Mask Set Errata for Mask 0M11F

This mask set errata applies to the mask 0M11F for these products:

- MC9S08RG60
- MC9S08RG32
- MC9S08RE60
- MC9S08RE32
- MC9S08RD60
- MC9S08RD32
- MC9S08RC60
- MC9S08RC32

Case 1

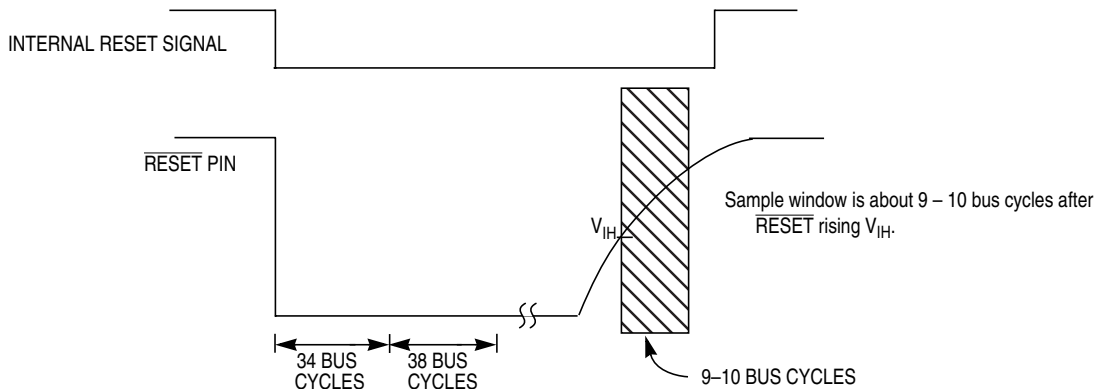
If a falling edge is detected on the external reset pin at either of two sample points, the MCU will cease operation and will recover only after a power-on reset.

Case 1 — After detecting a reset signal, either internal or external, the internal reset circuit latches the cause of the reset, forces a low level on the external $\overline{\text{RESET}}$ pin for about 34 bus cycles, releases the pin, and samples the pin level about 38 bus cycles later.

To avoid multiple edges on the $\overline{\text{RESET}}$ pin due to switch contact ringing or EMC noise, eliminate any voltage bounce through RC filtering. A 0.1 μF capacitor to ground and an external 4.7 k Ω to 10 k Ω resistor to V_{DD} works well to ensure noise suppression.

Case 2

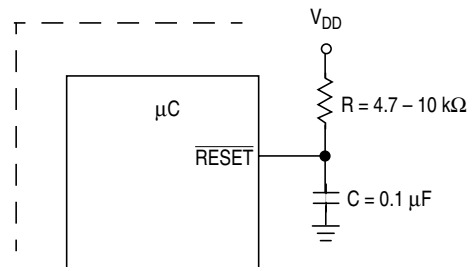
Case 2 — After remaining in reset for an extended period of time due to an externally applied low level on $\overline{\text{RESET}}$, the internal reset circuit will sample the pin level about 9 to 10 bus cycles after the pin raises above its V_{IH} level.

In addition to RC filtering, avoid spurious edges on the $\overline{\text{RESET}}$ pin caused by external active circuitry such as low voltage detectors and watchdog components. Do this by ensuring that external circuitry cannot drive $\overline{\text{RESET}}$ low within 10 bus cycles of the release of $\overline{\text{RESET}}$.
